## **Changes to the 2010 UAM References:**

Revisions to the 2010, 2012/2013, and 2013 Design Standards  
(See Below)

**FDOT 2014 DESIGN STANDARDS**  
**SUPPLEMENTARY DETAILS FOR MANHOLES & INLETS**

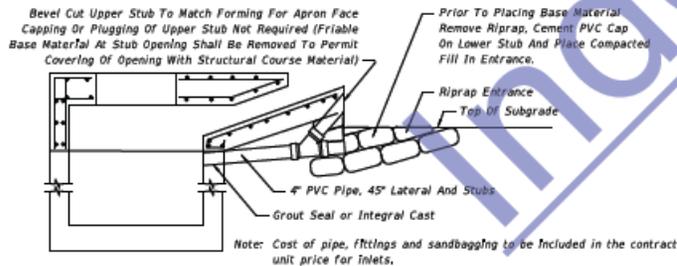
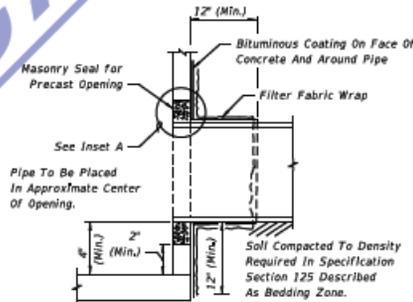
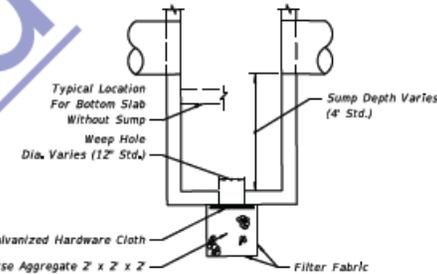
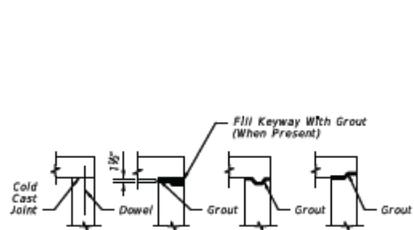
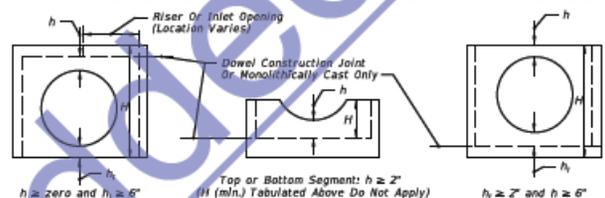
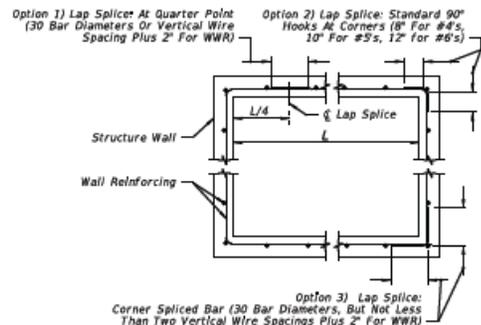
Std Index 201, Supplementary Details For Manholes & Inlets  
The UAM now references this entire standard index.  
(See Below)

**TRENCH CUTS AND RESTORATIONS ACROSS ROADWAYS**

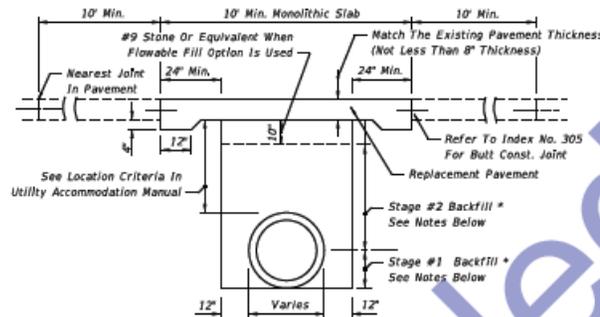
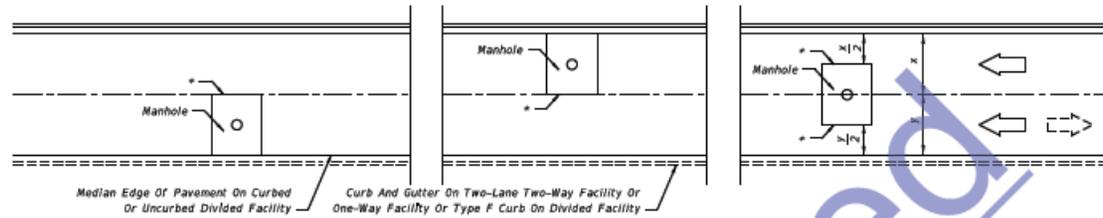
Std Index 307, Miscellaneous Utility Details  
The UAM now references the entire standard rather than just conflict structures.  
(See Below)
